DEVIATION REQUEST AND DECISION FORM

Project Name :	GRANDVIEW PHASE 3 (PUDSP-214)
Schedule No.(s) :	4200000475, 4200000474
Legal Description :	A TRACT OF LAND BEING A PORTION SECTION 21, AND A PORTION OF THE NORTHEAST QUARTER OF SECTION 28, TOWNSHIP 12 SOUTH, RANGE 64 WEST OF THE 6TH/ PRINCIPAL MERIDIAN, EL PASO COUNTY, COLORADO

A deviation from the standards of or in Section 2.2.4 of the Engineering Criteria Manual (ECM) is requested.

Proposed alternative cross section below:

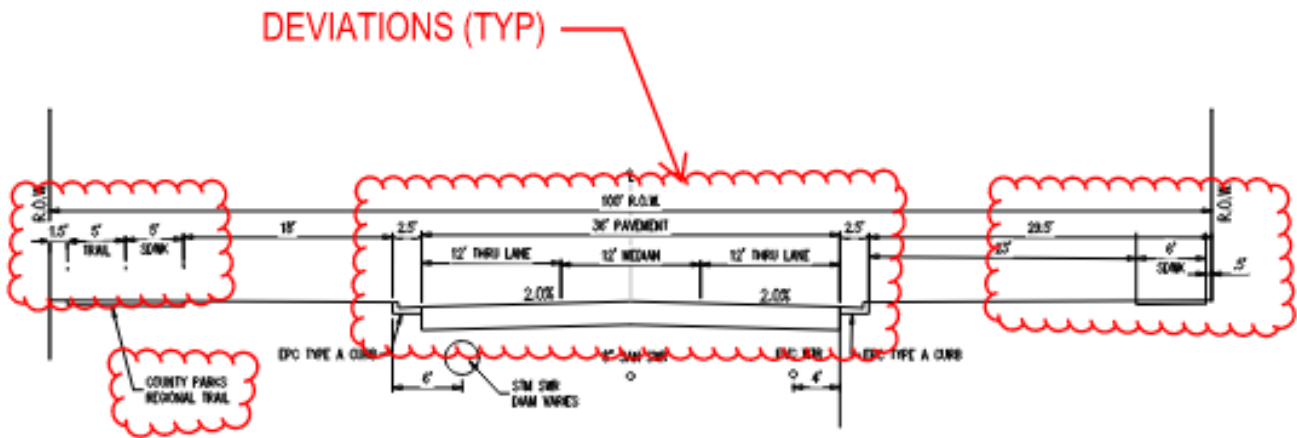
Figure 2-13. Typical Urban Minor Arterial Section. The figure shows the typical cross section with a pavement width of 62' and a tree lawn of 7'. The Modified Urban Minor Arterial Section ((2 Lane) proposes a pavement width of 36' and tree lawn widths of 18' and 23' but maintains the 100' R.O.W.

Explain the proposed alternative and compare to the ECM standards (May provide applicable regional or national standards used as basis):

Deviation based on need for the ECM to identify a 2 lane Urban Minor Arterial Roadway Section

The roadway section will not lower the Level of Service to an unacceptable range.

The deviation will not adversely affect maintenance and its associated cost. The proposed section will meet the traffic requirements and ultimately reduce maintenance and replacement costs associated with a pavement than is wider than necessary.

The deviation will improve the aesthetic appearance of the project and allow for widened tree lawn area between the back of curb and sidewalk.

The deviation meets the design intent and purpose of the ECM standards by providing the full 100' ROW width required by the Urban Minor Arterial Roadway while also meeting the required 2 lane roadway and allows for the median turn lane for necessary left turns. The additional ROW will allow for future roadway widening if warranted in the future.

Figure 2-13. Typical Urban Minor Arterial Cross Section

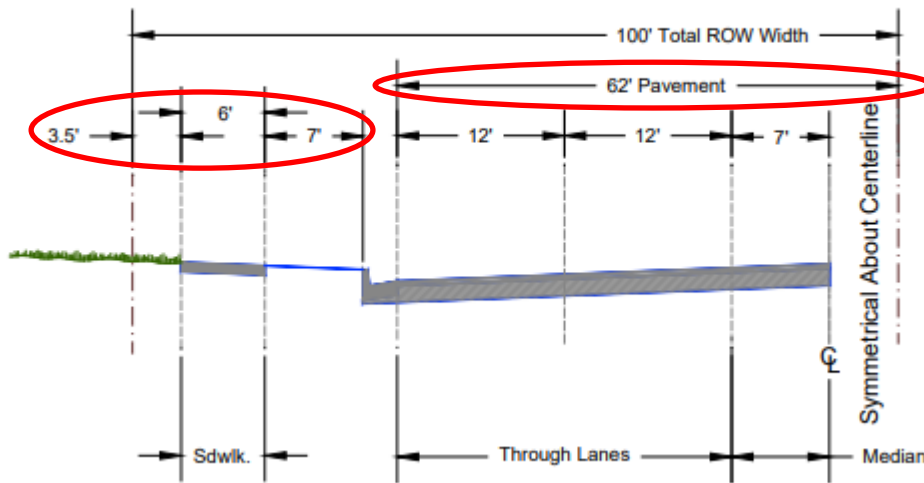
There is no typical section in the ECM for a 2 lane Urban Minor Arterial roadway
